Consistency Assessment Approval Form – Changes to design to integrate Pitt Street Station with the proposed over station development at the northern and southern portals

Existing Approved Project
Planning approval reference details (Application/Document No. (including modifications)): CSSI 15_7400 Sydney Metro City & Southwest – Chatswood to Sydenham
Date of determination: 9 January 2017
Type of planning approval: Part 5.1 – Critical State Significant infrastructure
<p>Description of existing approved project:</p> <p>The Chatswood to Sydenham component of Sydney Metro City & Southwest project comprises a new metro rail line, approximately 16 kilometres long, between Chatswood and Sydenham. New metro stations would be provided at Crows Nest, Victoria Cross, Barangaroo, Martin Place, Pitt Street and Waterloo, as well as new underground metro platforms provided at Central Station. The project has been subject to a number of modification applications. The CSSI Approval as modified allows for all works to deliver Sydney Metro between Chatswood and Sydenham Stations and also includes upgrade of Sydenham Station.</p> <p>The Environmental Impact Statement (EIS) identified that over statio

ATTACHMENT C: Pitt Street North OSD concept demarcation drawings (concept proposal SSD 17_8875)

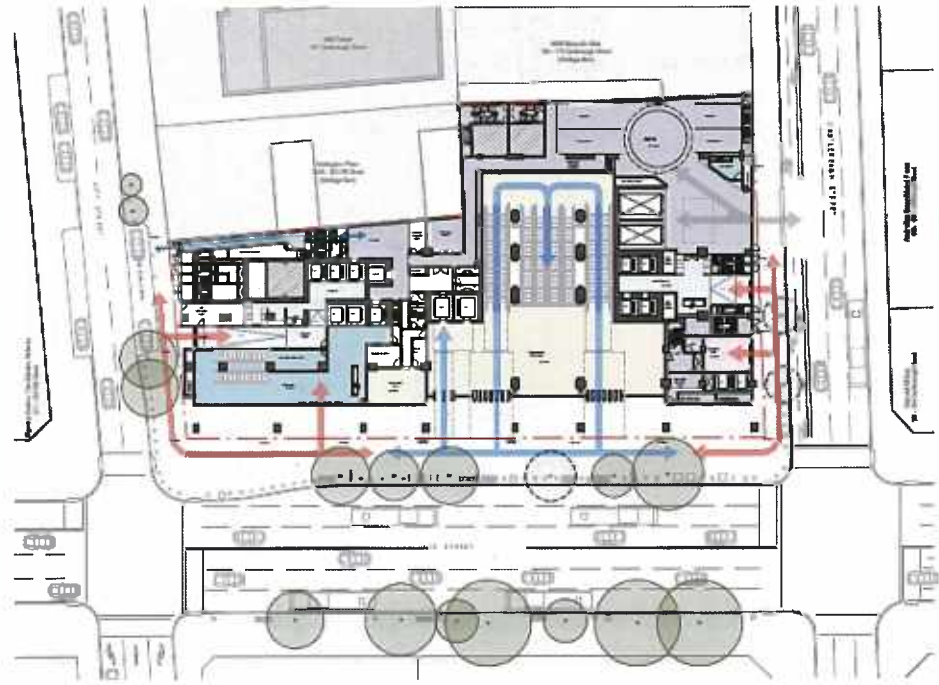
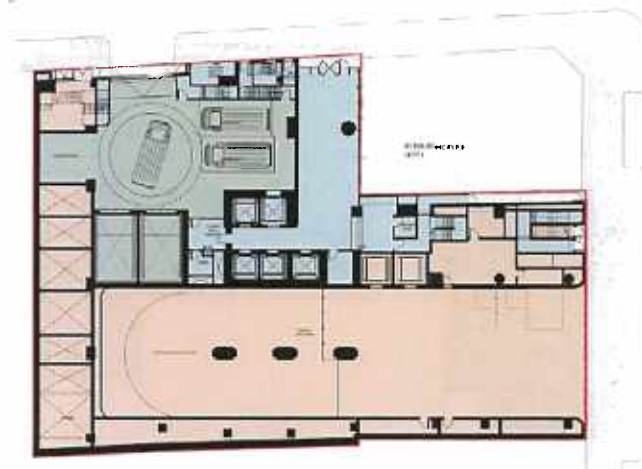
Ventilation	At Level 1, towards Park Street.	At Level 4, towards Park, Pitt & Castlereagh Streets.	Subject of this consistency assessment
Transfer Slab	RL 39.00	RL 48.00	Subject of this consistency assessment

The increase in height of the finished floor level of the transfer slab above both station portals is to accommodate the vertical integration requirements and space provisioning of the station ventilation system in order to meet the required engineering standards. For both portals, the increased height of the transfer slab is contained wholly within the podium form and therefore has no impact on the final built form of the integrated station development. The height at which ventilation occurs has been increased to accommodate the vertical discharge requirements since the reference design drawings assumed ventilation ducts could be located closer to the station entrances. As such, for Pitt Street North, station ventilation now occurs at Level 4 and is directed towards Park, Pitt and Castlereagh Street. For Pitt Street South, station ventilation now occurs across Levels 6 & 7 towards Pitt and Bathurst Streets.

ATTACHMENT D: Pitt Street South OSD concept demarcation drawings (concept proposal SSD 17_8876)

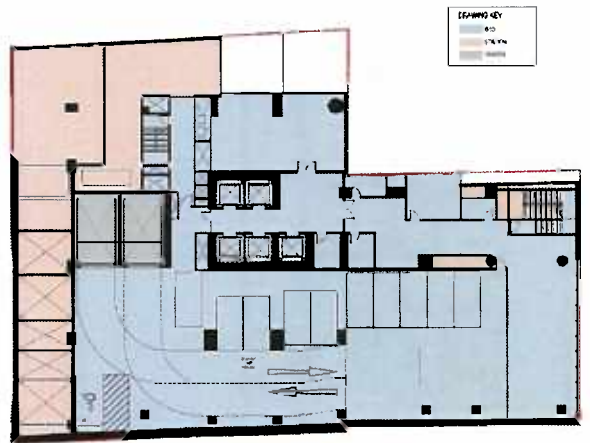
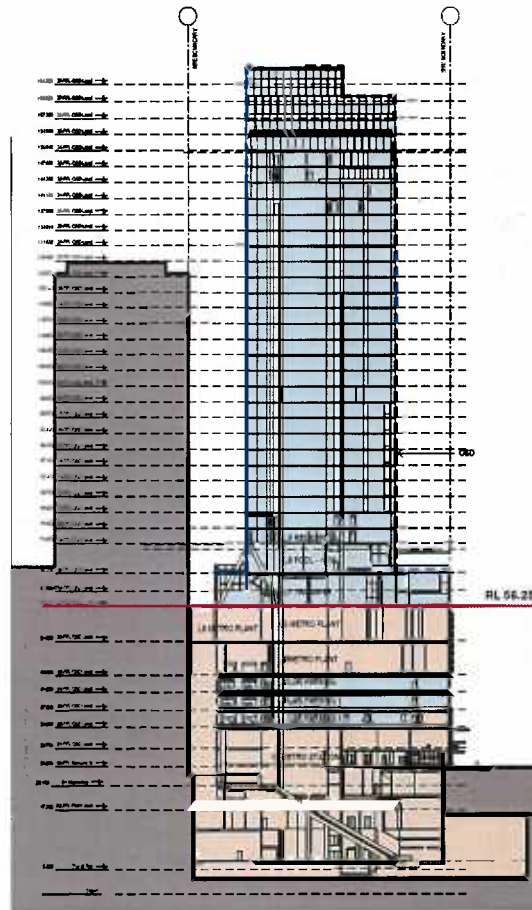
Loading & Servicing	Not specified	Shared between OSD and station with access via Pitt Street	Use of space provisioned for in the CSSI Approval subject to separate planning approval (concept SSD Application)
Ventilation	At Level 3, adjacent to Princeton Apartments and directed towards Pitt Street.	At Levels 6 & 7, towards Pitt and Bathurst Streets.	Subject of this consistency assessment
Transfer Slab	RL 52.80	RL 58.25	Subject of this consistency assessment
